SUBJECT: ALL PC-12 SERIES AIRCRAFT - VENDOR MODIFICATIONS FOR CREW SEATS

**REPLACEMENT OF SEAT
PAN CUSHION AND COVER**

318-25-04

318-25-05

LOCATION OF SERVICE BULLETIN CONTENT

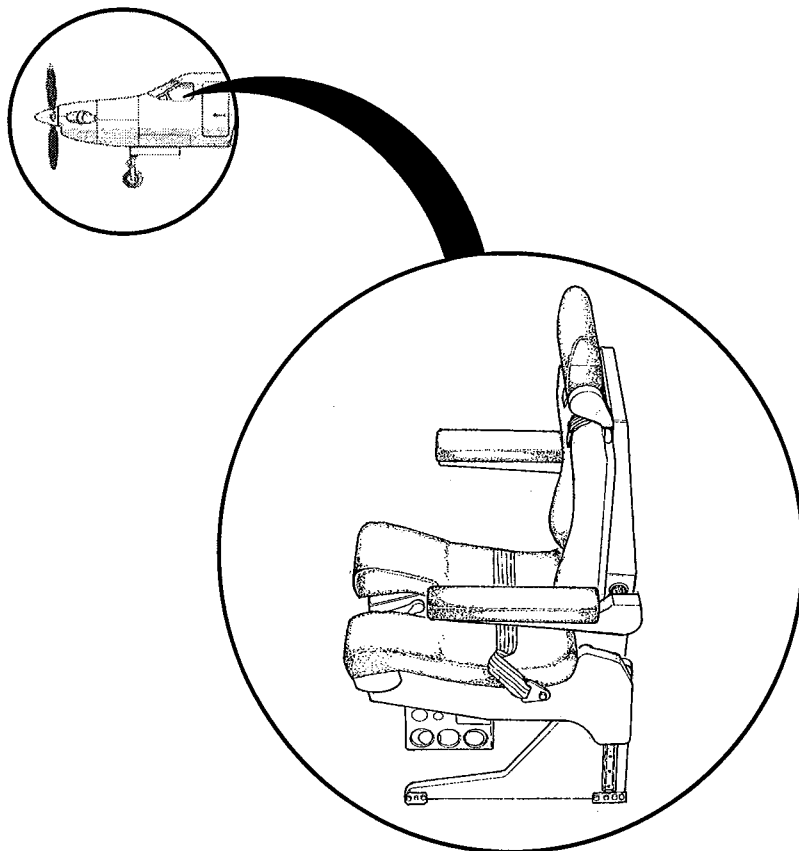
Request from customer for softer (lower density foam) seat pan cushion.

Removal of existing seat pan cushion and cover and fitting with new parts.

1. The following instructions can be carried out with the seat fitted on the aircraft. If the seat is removed from the aircraft refer to the aircraft maintenance manual for details.
2. Remove pan cushion (174) and cover (1-168) (1-168A). Refer to seat CMM.
3. Fit replacement cover (2) to new pan cushion (1) and locate onto seat making sure that the cushion is centrally positioned on the seat pan. Refer to seat CMM.
4. After modification, operator should mark by vibro-etch or similar method, the Service Bulletin number (318-25-04) and issue onto the seat identification label (nameplate) which is located on base structure back panel.

LOCATION OF SERVICE BULLETIN CONTENT

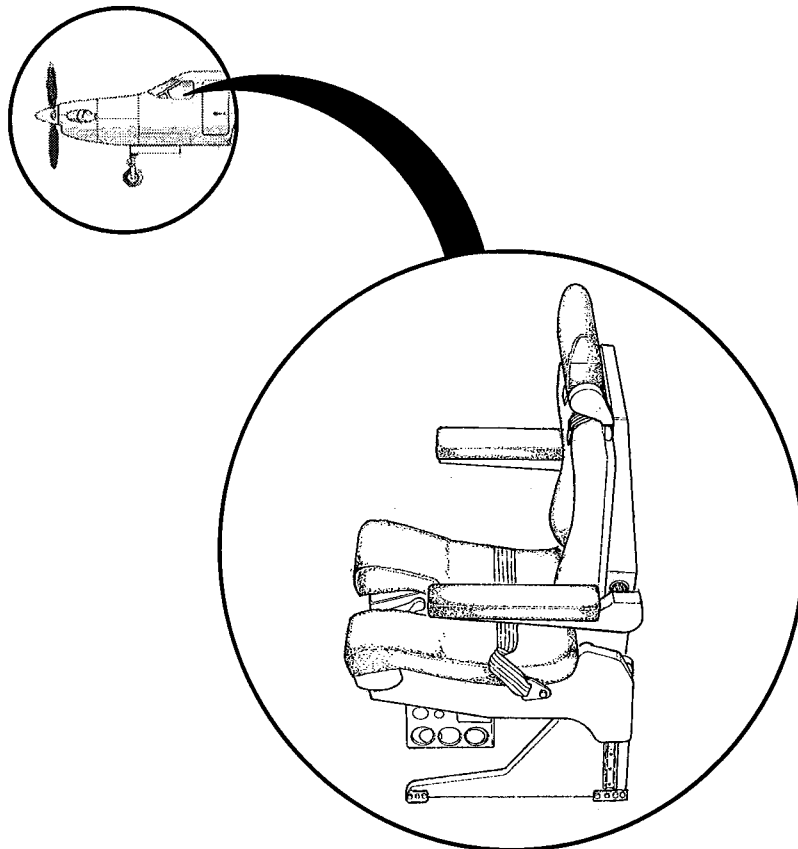
To allow the use of original pan cushion and cover on latest configuration seats.

Removal of existing pan cushion and cover and fitting with new parts.

1. The following instructions can be carried out with the seat fitted on the aircraft. If the seat is removed from the aircraft refer to the aircraft maintenance manual for details.
2. Remove pan cushion (175) and cover (1-169) (1-169A). Refer to seat CMM.
3. Fit replacement cover (2) to new pan cushion (1) and locate onto seat making sure that the cushion is centrally positioned on the seat pan. Refer to seat CMM.
4. After modification, operator should mark by vibro-etch or similar method, the Service Bulletin number (318-25-05) and issue onto the seat identification label (nameplate) which is located on base structure back panel.
